City of El Paso – City Plan Commission Staff Report

Case No: SUSU14-00109 – Desert Springs Unit 4
Application Type: Major Combination
CPC Hearing Date: December 4, 2014
Staff Planner: Joaquin Rodriguez, (915) 212-1608
rodriguezjx3@elpasotexas.gov
Location: North of Transmountain East of I10
Acreage: 63.08
Rep District: 1
Existing Use: Vacant
Existing Zoning: R-3A (Residential)
Proposed Zoning: R-3A (Residential)
Nearest Park: Desert Springs Park (.15 mi)
Nearest School: Alderette Middle (1.3 mi.)
Park Fees Required: None
Impact Fee Area: West Side Impact Fee Area
Property Owner: DVEP Land LLC
RPW Development
City of El Paso
Applicant: DVEP Land LLC
Representative: CEA Group

PRELIMINARY PLAT
SCALE: 1" = 100'

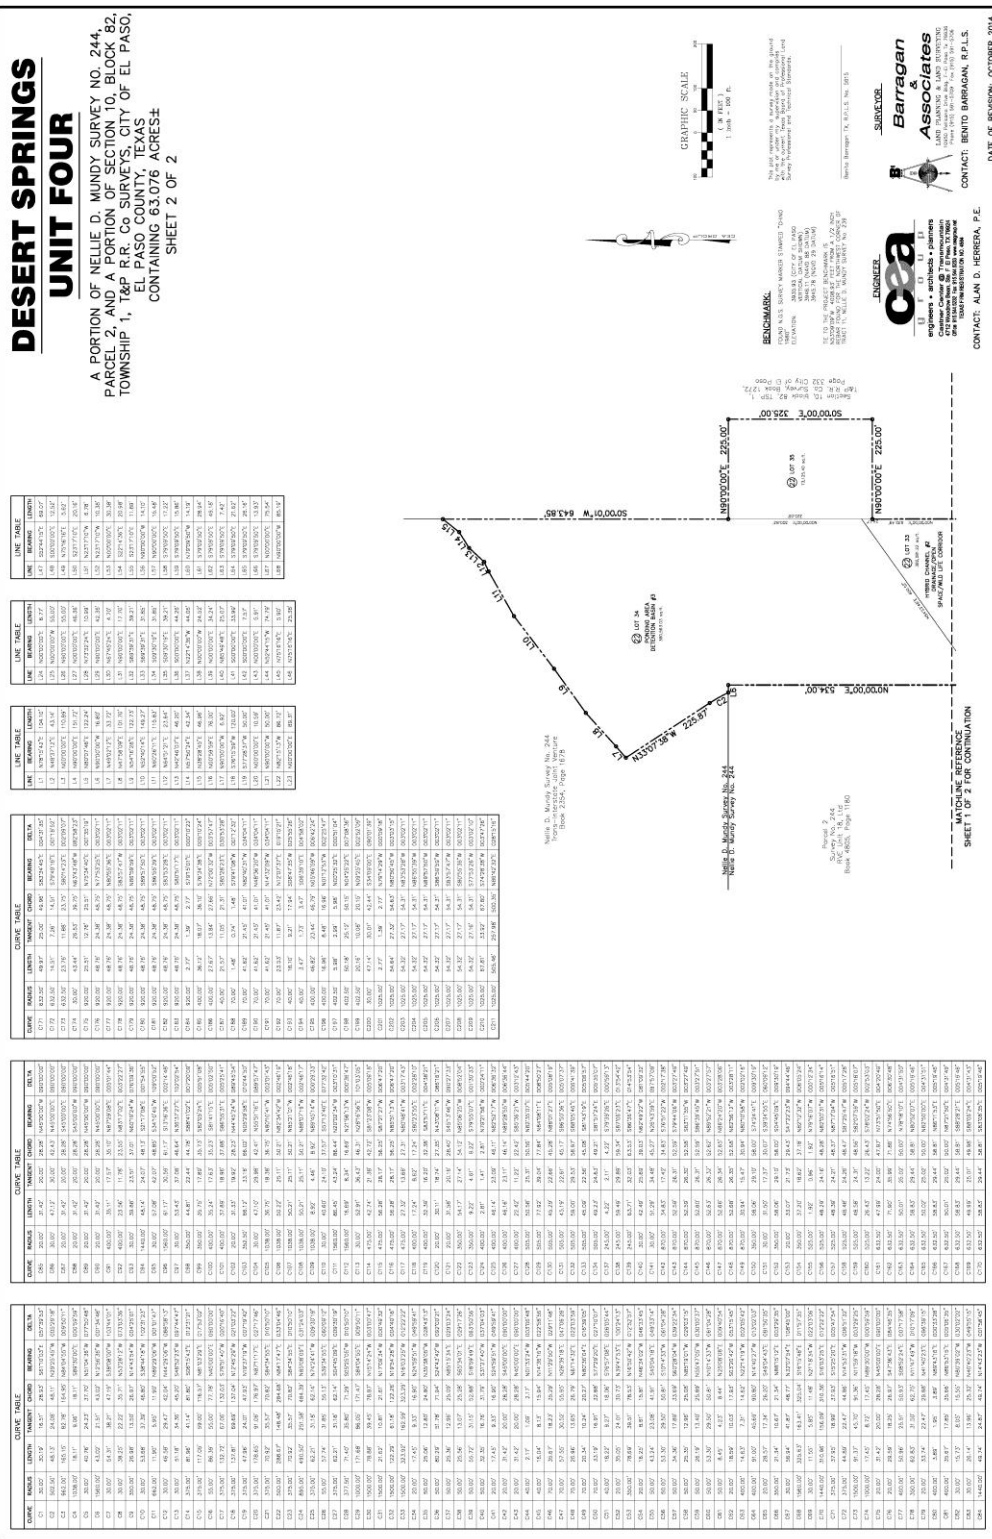
Show and label all existing street and drainage improvements, drainage flow patterns and label existing contours on preliminary plat.

1. Eliminate PSB easement within Lot 34, Block 15; sewer to be designed to avoid easement thru property.
